AMENDMENTS TO THE DRAWINGS

REMARKS

Claims 1-4, 7, 8, 11-14, 17, 18, and 21-35 are pending in the present application. Claims 1-5, 7, 8, 11-14, 17 and 18 have been amended to better describe the present invention. Claims 5, 6, 9, 10, 15, 16, 19 and 20 have been canceled. Claims 21-35 are new.

FIG. 8(b)

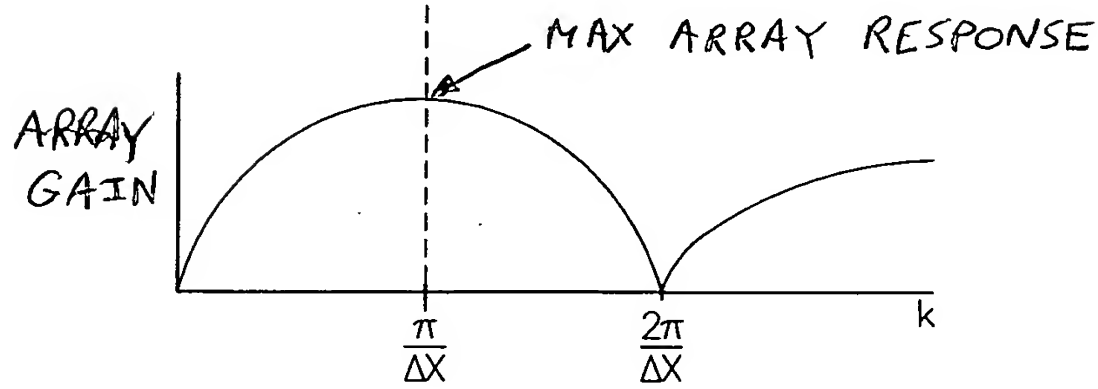
The attached sheet of drawings includes changes to Fig. 8(a). This sheet, which includes Figs. 8(a), 8(b) and 8(c), replaces the original sheet including Figs. 8(a), 8(b) and 8(c). In Fig. 8(b), previously omitted element Array Gain Plot has been added.

1. Examiner objected to portions of the disclosure. Applicants have amended the disclosure and request that these objections be withdrawn.
2. Examiner objected to Fig. 8(b). Applicants have amended Fig. 8(b) to include text to describe the plot as an Array Gain plot. Applicants request that this objection be withdrawn.
3. Claim 12 has been objected to because of informalities. Claim 12 has been amended to depend from claim 11. Applicants request that this objection be withdrawn.
4. The Examiner has rejected claims 1-3, 5-6, 10-13, 15-16 and 20 under 35 U.S.C. 102(b) as being anticipated by Baumuel (6,026,693).
